VIRGINIA ELECTRIC AND POWER COMPANY
RICHMOND, VIRGINIA 23261

REQUEST FOR ADDITIONAL INFORMATION
REACTOR COOLANT SYSTEM VENTS (ITEM II.B.1)
NORTH ANNA POWER STATION UNITS 1 AND 2

REQUEST FOR ADDITIONAL INFORMATION
FOR
NORTH ANNA 1 & 2

RCS VENT SYSTEM DISCHARGE POINTS

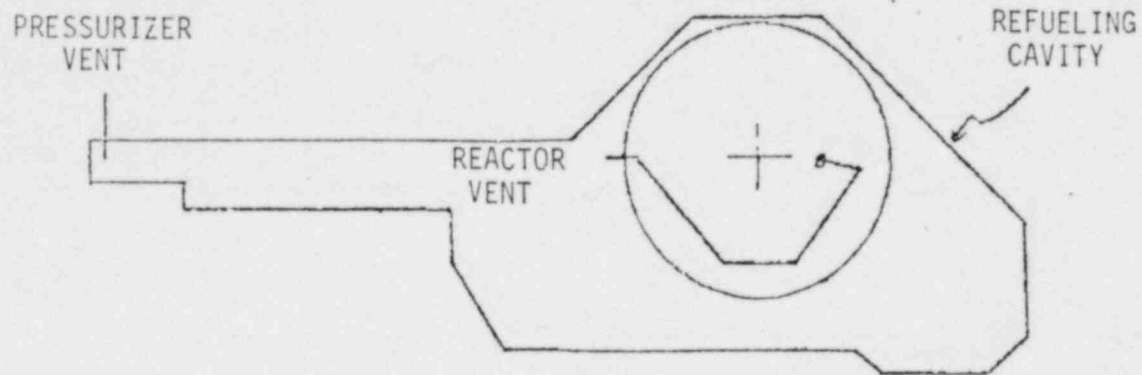
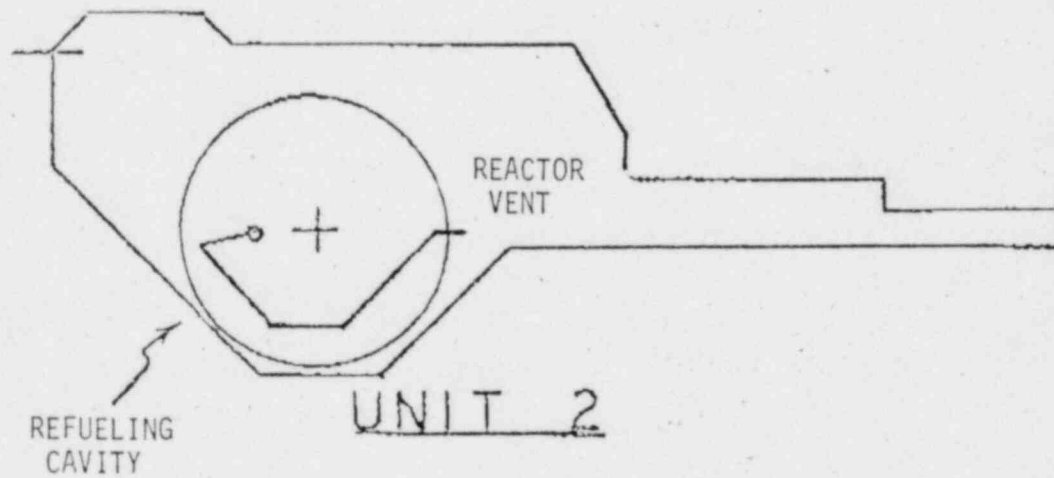
4. Demonstrate, using engineering drawings (including isometrics) and design descriptions as appropriate, that the anticipated discharges of steam, liquid and noncondensable gas from the RCS vents to the refueling cavity will not adversely affect any nearby structures, systems, and components essential to safe shutdown of the reactor or mitigation of a design basis accident.

Response: The spray from both the RCS and Pressurizer Vent Systems are directed into the refueling cavity such that they do not impinge on any components. The pressurizer vent system discharge is directed straight down into the refueling cavity. The RCS Vent System discharge is directed at a 45° angle into the refueling canal from the reactor vessel head. The attached sketch (Attachment III) details the approximate location of the vent system discharge for both units. All components in this area were originally designed or have been qualified to withstand the effect of a LOCA, therefore, no additional analysis need be performed.
